Well Name: STACK CATS 25_36 FED COM	Well Location: T22S / R32E / SEC 24 / SWSW / 32.3708043 / -103.6328724	County or Parish/State: LEA / NM
Well Number: 12H	Type of Well: OIL WELL	Allottee or Tribe Name:
Lease Number: NMNM2379	Unit or CA Name:	Unit or CA Number:
US Well Number:	Operator: OXY USA INCORPORATED

Notice of Intent

Type of Action: APD Change

Procedure Description: OXY USA Inc., respectfully requests to amend the subject AAPD to revise the SHL, BHL, HSU, Pool, TVD, Target Formation and Drill Plan. Old SHL: 275' FSL 1245' FWL New SHL: 275' FSL 1335' FWL Old BHL: 20' FSL 1210' FWL New BHL: 20' FNL 430' FWL Old HSU: 640 acres New HSU: 1280 acres Old Pool: RED TANK, BONE SPRING New Pool: WC-025 G-09 S223332A, UPR WOLFCAMP Old TVD: 9578' New TVD: 12072' Old Target Formation: BONE SPRING New Target Formation: WOLFCAMP *THERE IS NO ADDITIONAL SURFACE DISTURBANCE RELATED TO THIS SUNDRY" Attached is the updated C102, drill plan, directional, Blanket Design, NSHSU order and APD Change Worksheet.

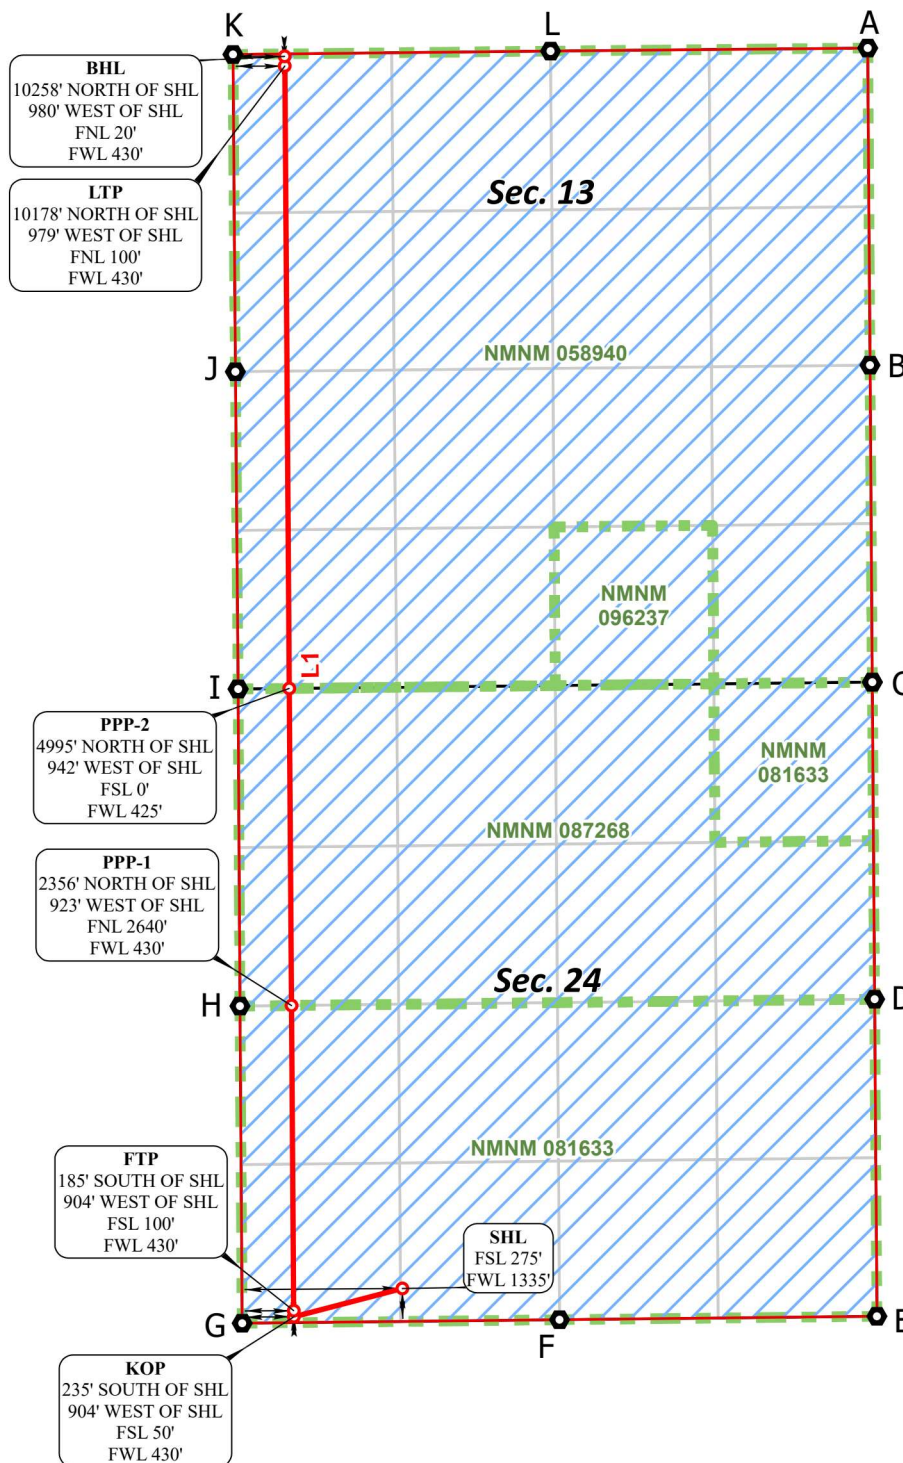
Old SHL: 275' FSL 1245' FWL
New SHL: 275' FSL 1335' FWL

Old BHL: 20' FSL 1210' FWL
New BHL: 20' FNL 430' FWL

Old HSU: 640 acres
New HSU: 1280 acres
